Access Compliance Report

Public Rights-of-Way (Curb Ramps)

Intersection ID: 48555	Main Street: COTTON_PRESS_RD	Cross Street: RIDGEFOREST_DR	Location: SE
ADA ID: 73116F05CBF5	Ramp Type: PerpDiag	Initial Pass/Fail: Pass	Overall Compliance: No
		Severity Score: 0

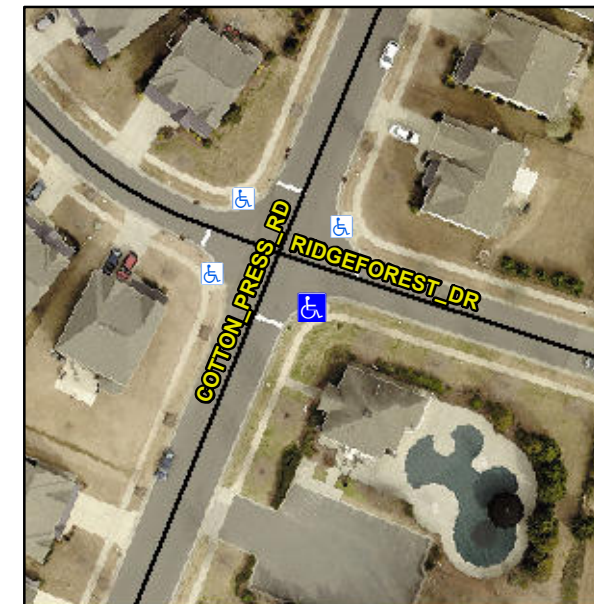
Not Found, R304.2.1, R304.2.2-Perp, R304.3.2-Para, R304.5.3

Compliance	Description	Data	Compliance	Description	Data
N/A	Ramp Length (in)	72.0	Yes	Ramp Slope (%)	7.5
Yes	Ramp Width (in)	48.0	Yes	Ramp XSlope (%)	1.5
N/A	Flare Type LT	Sloped	N/A	Flare Type RT	N/A
N/A	Flare Slope LT (%)	4.6	Yes	Flare Slope RT (%)	9.6
N/A	Flare Traversable LT?	Yes	N/A	Flare Traversable RT?	Yes
Yes	Landing Length (in)	48.0	Yes	DWS Provided?	Yes
No	Landing Width (in)	47.0	Yes	DWS Contrast?	Yes
No	Landing Slope (%)	2.3	Yes	DWS Length (in)	24.0
Yes	Landing X Slope (%)	1.8	Yes	DWS Full Width?	Yes
N/A	Landing Curb? (Y/N)	No	Yes	DWS Offset (in)	1.0
N/A	Shared Landing?	No			
Yes	Gutter Ponding?	No	Yes	Gutter Slope (%)	1.6
Yes	Gutter Lip Ht (in)	0.0	No	Gutter X Slope (%)	3.3
N/A	Painted X Walk1?	No	N/A	Painted X Walk2?	No
	X Walk 1 Direction	To NE		X Walk 2 Direction	To NW
N/A	X Walk 1 Width (in)	N/A	N/A	X Walk 2 Width (in)	N/A
	X Walk 1 Slope (%)	0.1		X Walk 2 Slope (%)	3.3
	X Walk 1 X Slope (%)	3.4		X Walk 2 X Slope (%)	0.5

Remove & Replace Curb Ramp With Two New Directional Ramps or Equivalent. Remove & Replace Gutter.
